CALIFORNIA COASTAL COMMISSION

REVISED CONDITIONS AND FINDINGS

Appeal No.: A-6-OCN-13-008

Location: 1513 South Pacific Street, Oceanside (San Diego County)

EXHIBIT NO. 16
APPLICATION NO.
A-6-OCN-13-008
Applicant stringline location

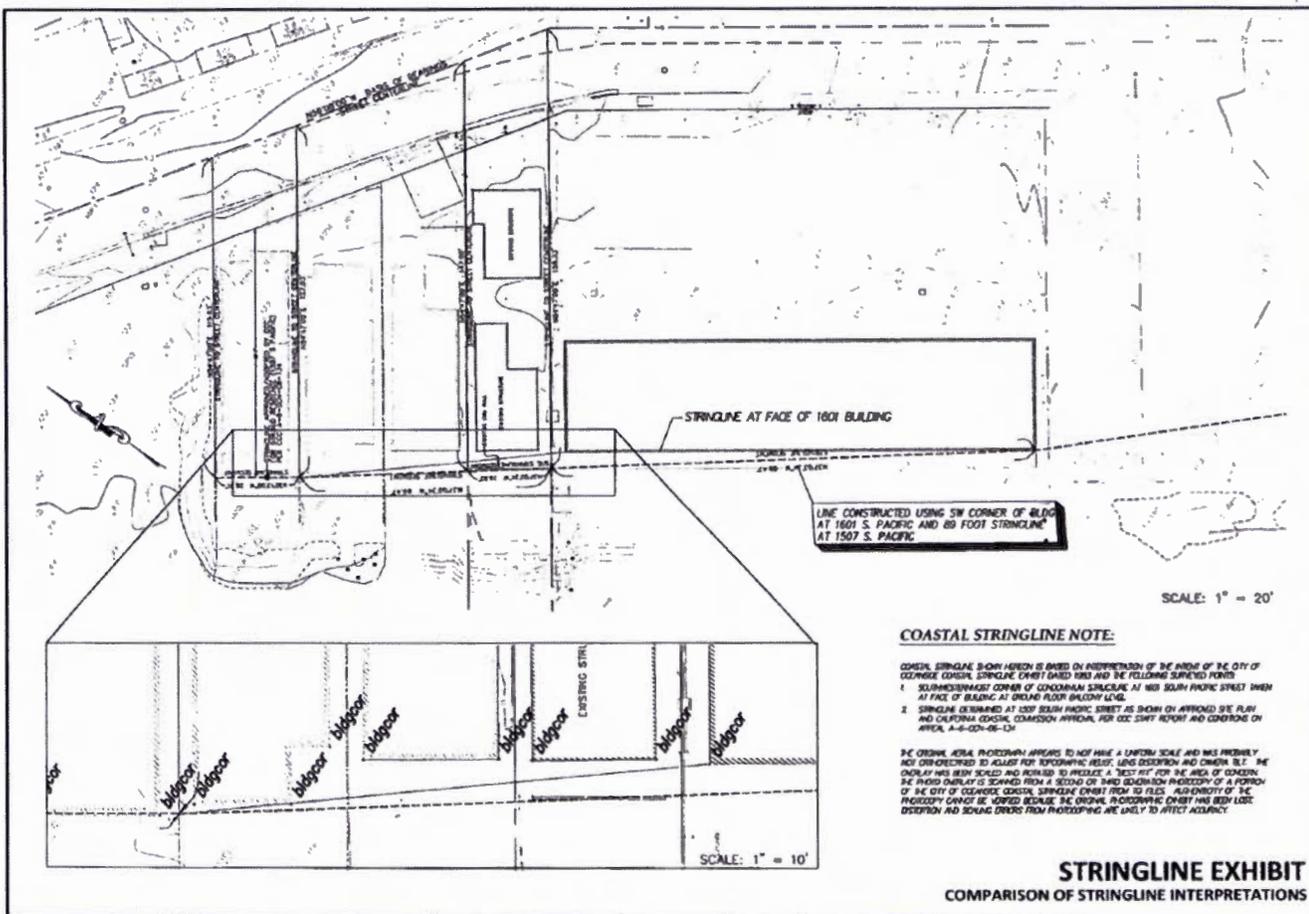
In addition, the proposed project may also have cumulative impacts on public views through the creation of a new precedent. The use of appurtenances as a point from which to measure a stringline for proposed development may encourage shorefront property owners to seek to use decks and walls beyond the City's established stringline points both on the immediately adjacent properties, as well as City-wide which may also encroach into existing public views, similar to the proposed development. As such, **Special Condition #1** requires the applicant to submit final plans that redesign the structure to be consistent with the stringline setback 112.34' west of the property line on the north side of the property 121.14' west of the property consistent with previous Commission action and as recommended by the City's planning staff. However, decks, balconies, wingwalls, etc., may extend beyond this setback, if approved by the City of Oceanside. In addition, **Special Condition Nos. 8, 9, & 10** require the submittal of as-built plans, require that all future development be reviewed by the Coastal Commission, and require the recordation of a deed restriction respectively. These conditions will ensure that the structure is built as approved by the Commission, and that all future development will be sited consistent with the established stringline setback for this section of the City.

REVETMENT PLAN VIEW
JUNE 2012

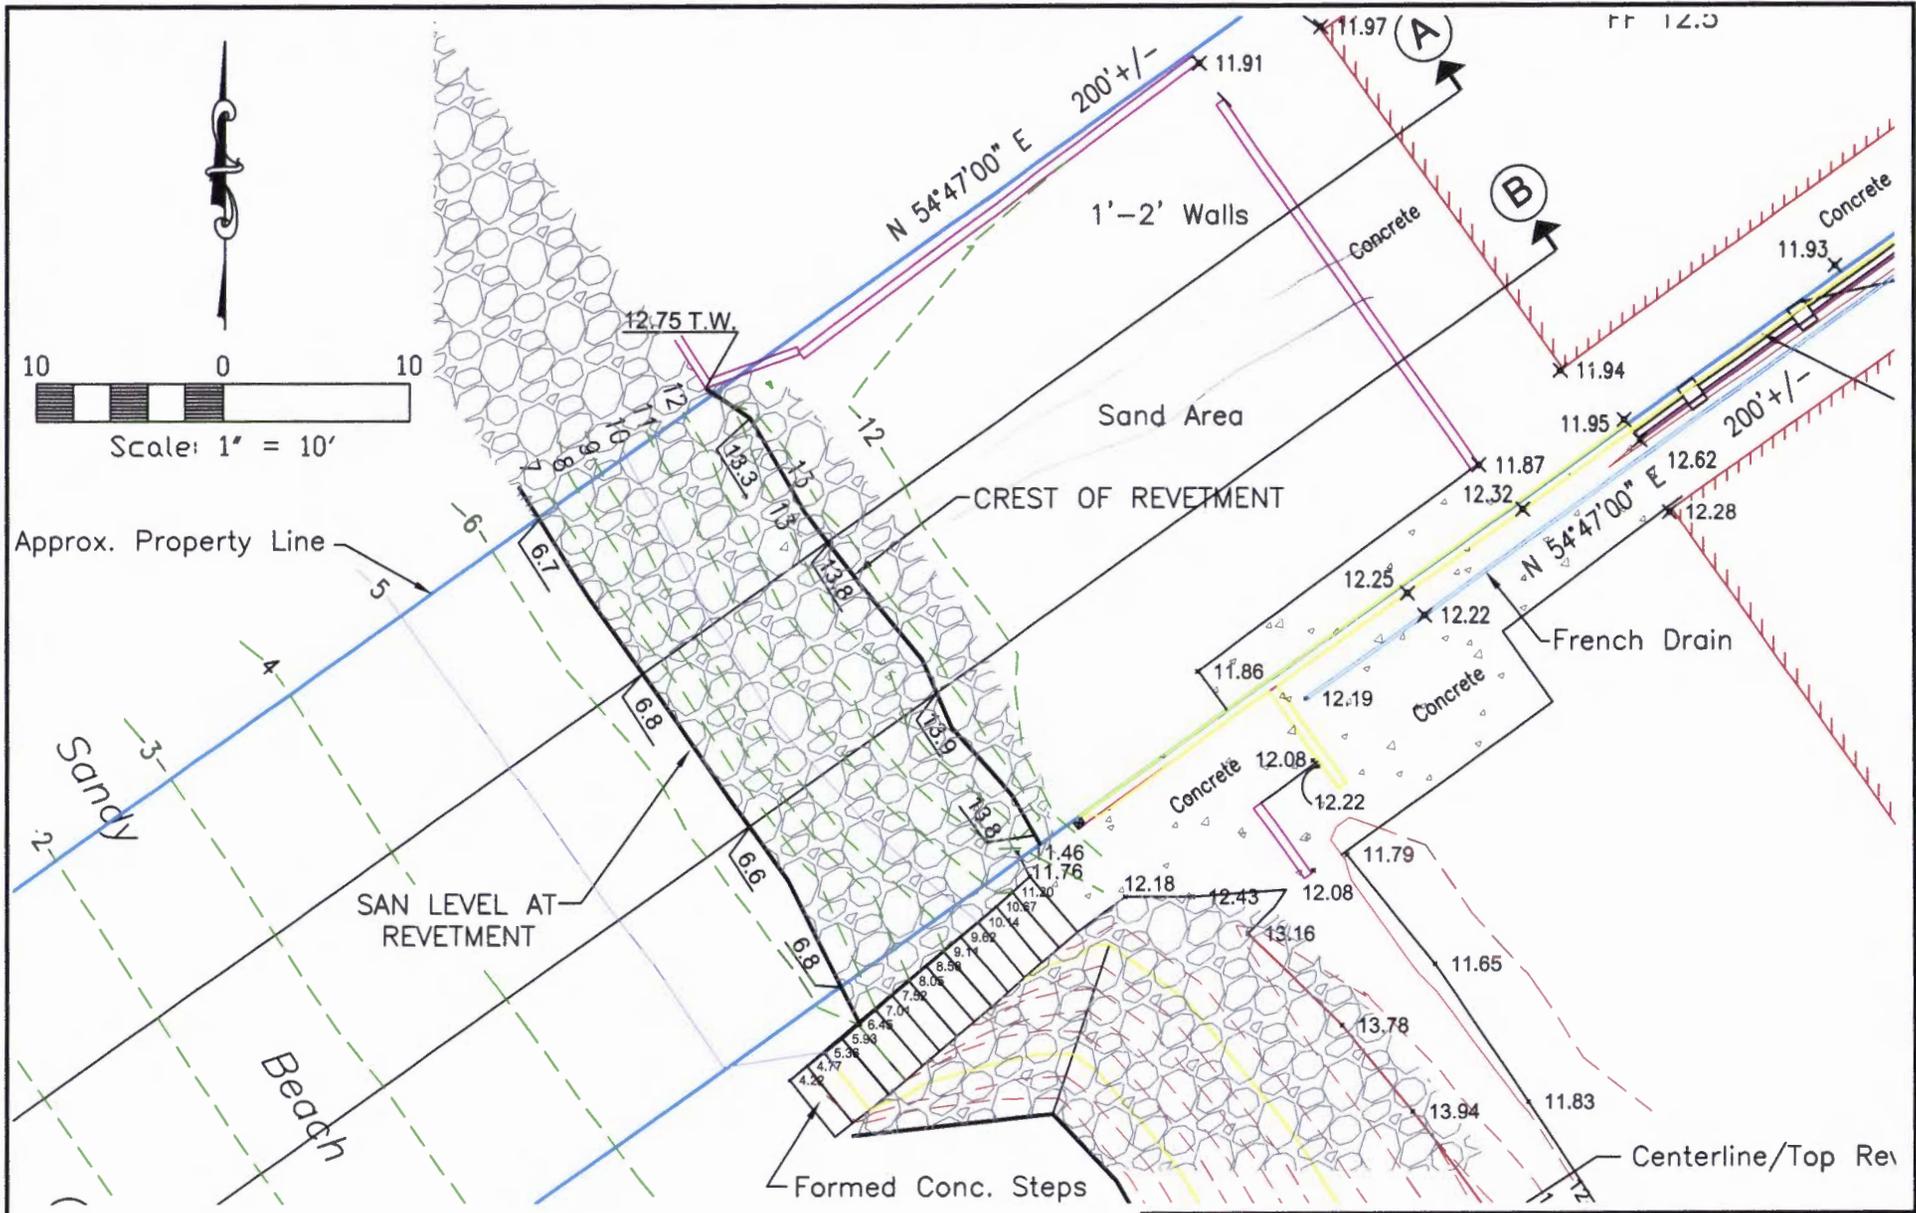
- a. The toe of the revetment shall extend no further seaward than established and shown on the revetment plans submitted by Taylor group Inc., dated June, 2012 and at a slope of 2/1.

- b. The top of the revetment shall not exceed elevation +13.5 MSL at any point.
3. **Long-Term Monitoring Program.** PRIOR TO THE ISSUANCE OF THE COASTAL DEVELOPMENT PERMIT, the applicant shall submit for review and written approval of the Executive Director, a long-term monitoring plan for the existing shoreline protection. The purpose of the plan is to monitor and identify damage or changes to the revetment such that repair and maintenance is completed in a timely manner to avoid further encroachment
